RESPONSE "A"

Applicants are responding to the Office Action mailed December 24, 2003. Claims 1-10 are pending in the present application. Applicants are traversing the U.S. §103(a) rejections and are submitting formal drawings. Please reconsider the identified patent application in view of the following remarks. Applicants believe that no new matter has been added by this response.

Prior Art
FIG. 1

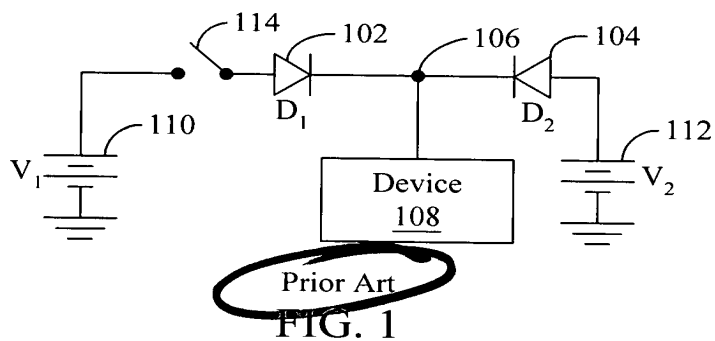
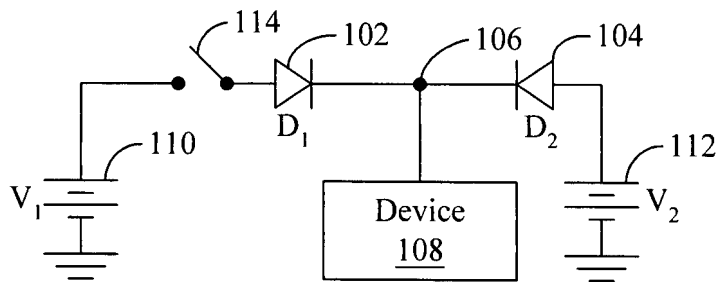
The Examiner objected to figure 1 and requested that “—Prior Art —” be added to the figure. Applicants have made the requested change and are submitting formal drawings for review by the Examiner. Two sets of the formal drawings are being submitted with one set for the Examiner and the other set for the Draftsperson. Each set contains a clean copy and a copy with drawing changes marked in red. Applicants ask that the formal drawings be accepted.
